EVALUATION OF AMENDED RESPONSE AND VERIFICATION OF CORRECTIVE ACTION AND CLOSURE OF DEFICIENCY REPORT (DR) YM-97-D-014 RESULTING FROM OFFICE OF QUALITY ASSURANCE (OQA) AUDIT K/PB-ARC-97-06 OF KIEWIT/PARSONS BRINCKERHOFF

YUCCA MOUNTAIN SITE CHARACTERIZATION PROJECT NONCONFORMANCE REPORT

NCR. No. YMSC-96-0035

EXHIBIT D - SECTION C

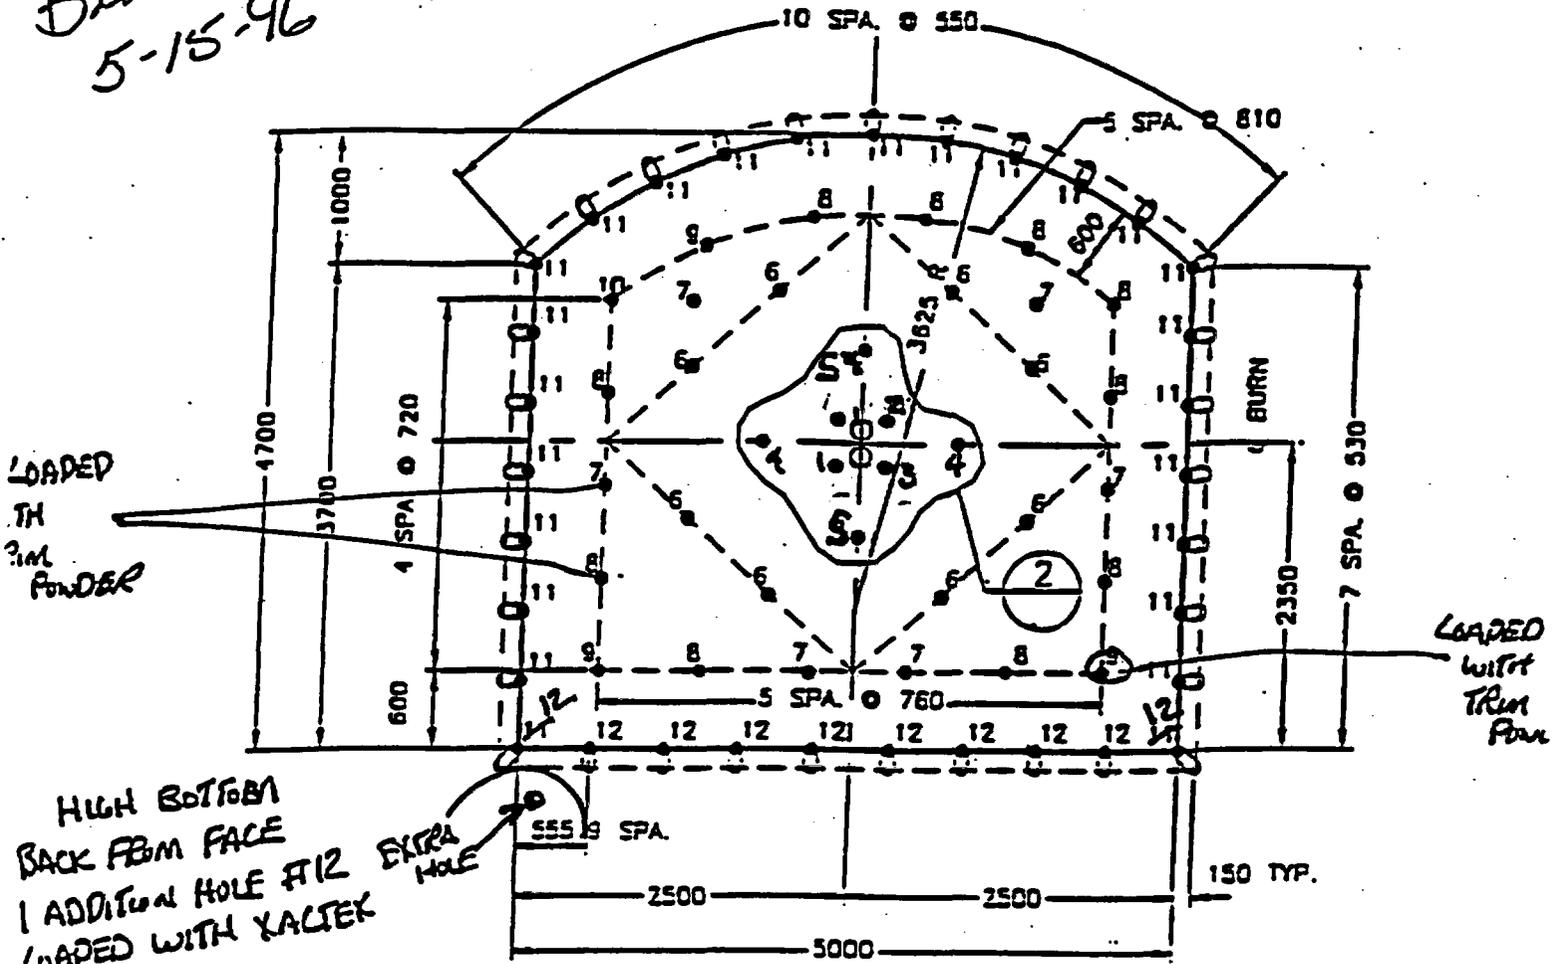
Contrary to the referenced requirements during monitoring of Drill and Blast Operations in Alcove No. 5 on 5/15/96, Blast I.D. No. 5-03, the following listed items were not in accordance with Plan-005 and the changes were not recorded on the Controlled Drill and Blasting Record Form:

- 1) Plan-005 specifies 1.2 or 1.8 m Round Loading. The blast hole drilled lengths measured 8ft. (2.4m).
- 2) Perimeter holes were loaded with one stick Geldyne and three sticks of Xactex. This is not in accordance with Plan-005 Exhibit D-Section C.
- 3) Remainder holes were loaded with ten sticks of Geldyne except for bottom right rib Delay #9 was loaded with one stick Geldyne and three sticks of Xactex. This is not in accordance with Plan-005 Exhibit D-Section C.
- 4) Plan-005 Exhibit A Burn Pattern 2 delay changes were made as follows: Delay #2 changed to Delay #1, Delay #3 changed to Delay #2, and Delay #1 changed to Delay #2.

5) The top expansion hole shown on Plan-005 Exhibit A Burn Pattern 2 was loaded with Delay #1.

6) Plan-005 Exhibit D-Section C the bottom left and right rib Delay #11 was changed to Delay #12.
